**Byers Gill Solar  
EN010139**

# 8.7 Comments on Local Impact Reports

Deadline 2 - August 2024

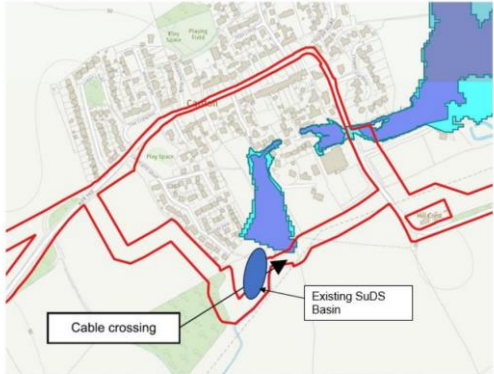
Reference	Topic summary	RWE response
	 <p data-bbox="504 507 593 523">Figure 1 Footpath 4</p> <p data-bbox="479 536 1211 943">The Applicant will be aware that it is an offence to disturb or obstruct a public right of way; if any works undertaken adjacent to, or on a PRoW, will disturb the surface or create an obstruction, either permanent or temporary, permission needs to be obtained from Stockton Borough Council prior to these works been undertaken. If as a result of the works public access cannot be maintained an application for a temporary closure order would need to be made. Likewise, if there is any potential health and safety risks to the public using a route while works are being undertaken an application to temporary close the footpath would need to be made. It is advisable for the Applicant to take photographs of the routes before works commence and again after the works are completed, such that they hold evidence that any route is in at least as good a condition after the works, as it was before.</p>	<p data-bbox="1272 209 2074 328">provided by the DCO, should consent be granted. As secured via Requirement 14 of the DCO, the Applicant will provide an updated PRoW Management Plan upon the appointment of a principal contractor, and any works to PRoW will be implemented in accordance with said Management Plan.</p> <p data-bbox="1272 341 2040 464">The Applicant will continue to engage with Stockton-Borough-Council on this matter to seek clarity on the alignment of Public Footpath 4 and, if considered appropriate, provide an update to ES Chapter 9 Land Use and Socioeconomics [APP-032] during the Examination.</p>
